SUBJECT: IN THE MATTER OF 238 NUCLEAR ISLAND  
GENERAL ELECTRIC STANDARD SAFETY ANALYSIS REPORT (GESSAR II)  
DOCKET NO. STN 50-447

SUPPLEMENTAL RESPONSE AND PROPOSED RESOLUTION TO DISCUSSION  
ITEMS

SUPPLEMENTAL RESPONSE TO  
INSTRUMENTATION AND CONTROL SYSTEMS BRANCH  
QUESTION ON MANUAL INITIATION OF SAFETY SYSTEMS

421.32 RESPONSE SUPPLEMENT

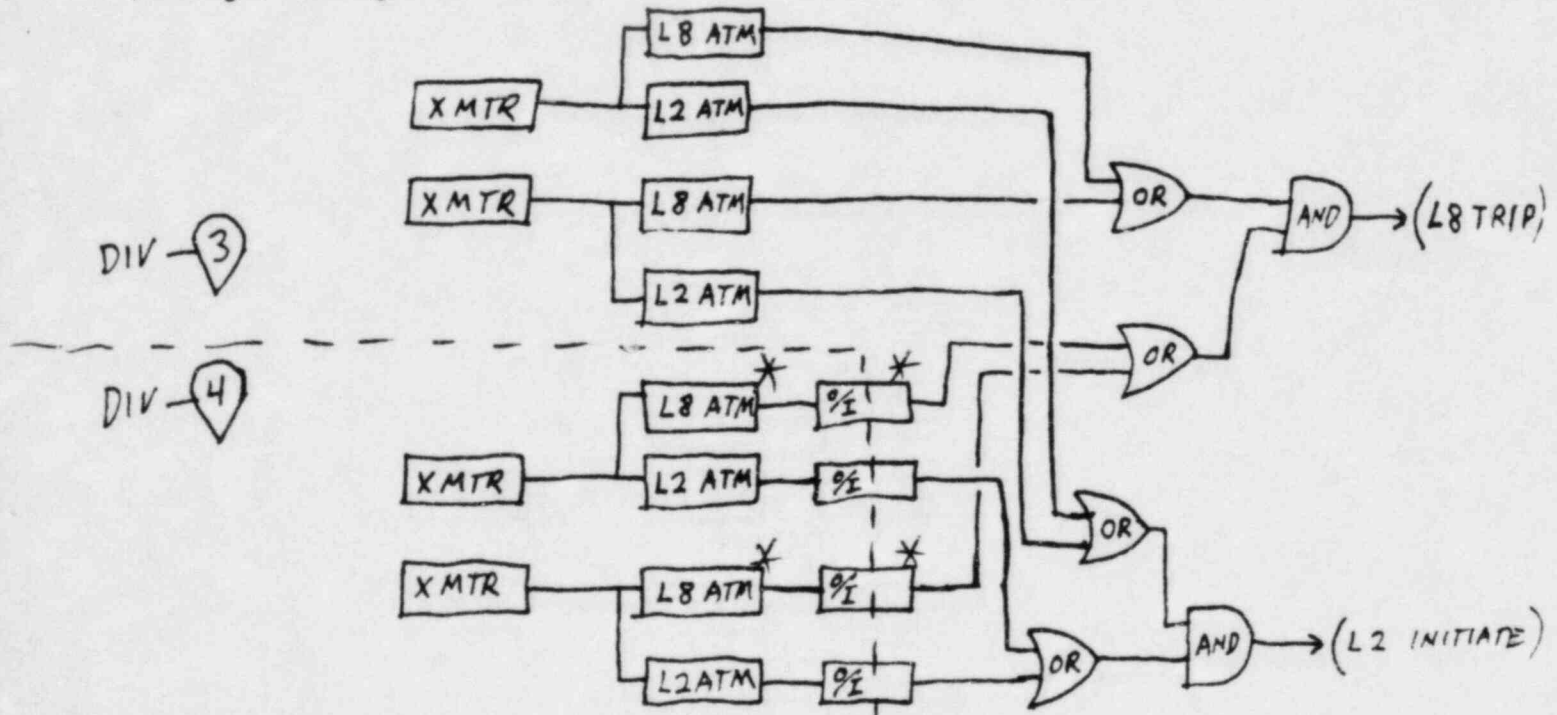
(Change HPCS description only per attached)

The HPCS subsystem is initiated automatically by a LOCA signal (low reactor water level in a 1-out-of-2-twice logic arrangement or high drywell pressure in 1-out-of-2-twice logic) or manually by a system level armed pushbutton. In addition, the subsystem can be placed in operation by use of an individual remote manual switch for each valve and the pump. In all three initiation modes, the injection valve is interlocked closed by high water level (level 8) in a ~~1-out-of-2~~ <sup>2-out-of-2</sup> logic arrangement. If the valve is open, high water level (level 8) will cause it to close.

The level 8 signal is provided by <sup>\*</sup>four analog trip modules (ATM's) which are paired with four separate transmitters. These four transmitters also provide the four inputs used in the 1-out-of-2-twice, low-water-level system initiation circuit. The following sketch illustrates the above explanation:

The four level 8 ATM's provide the common interlock for injection valve opening in the automatic initiation mode and the two manual initiation modes.
